Six Chuter Inc.  
**SAFETY DIRECTIVE**

<b>LEVEL</b>	<b>MANDATORY</b>
<b>DATE</b>	09/01/2009
<b>SB NUMBER</b>	SD 2009-01
<b>APPLICABLE MODELS &amp; CATEGORIES</b>	Legend XL Beginning Serial Numbers 3049

- 1.0 Planning Information
  - 1.1 Aircraft Affected
    - 1.1.1 Problem was noted on Legend XL 3091 and 3094. No other reports with this issue have been reported on any model
  - 1.2 Concurrent Bulletins
    - 1.2.1 Service Letter 2009-02 (2010 Outrigger Updates)
  - 1.3 Reason
    - 1.3.1 Stress crack in upper attachment bracket for rear outrigger support tube. Owner during pre-flight noticed stress crack in brackets on both side outriggers. Owner on second unit noted deformity of bracket and broke bolt while in flight. It was determined that on affected units the brackets were 1 ¼" 14 Gauge. The maintenance manual requires this bracket to be 1 ¼" 12 Gauge. It is additionally determined that the support cable tang that is installed under the bracket, can lead to unnecessary stress on this installation.
  - 1.4 Subject
    - 1.4.1 Outrigger support bracket stress crack

Crack from Bolt to outside edge of bracket

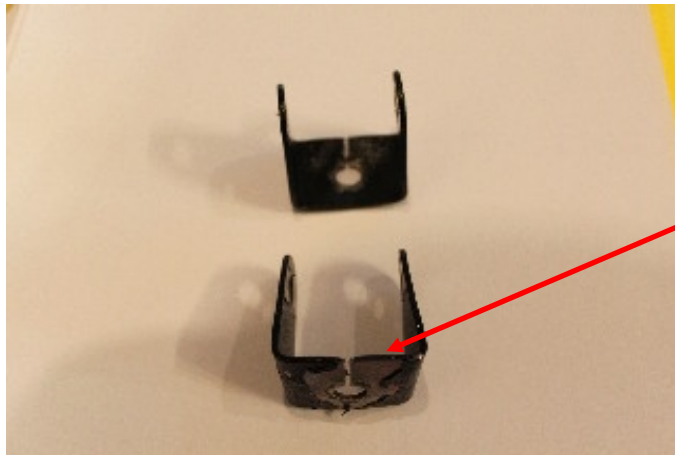
1.5.1 **CORRECT BRACKET** Owners of any Six Chuter with the new outriggers must check for signs of stress on brackets connecting the front and rear support tubes to the outrigger and to the deck. This inspection should determine whether the wrong gauge bracket is installed.

Incorrect 14 Gauge Bracket

Correct 12 Gauge Bracket

1.5.1.1 Owners who discover any signs of cracking on this component should not fly their aircraft until the crack is repaired by replacing the affected bracket. Six Chuter recommends replacement of these MA 3744 1 ¼" 14 gauge brackets with heavier bracket part number STP 115 1 ¼" U Bracket 12 Gauge
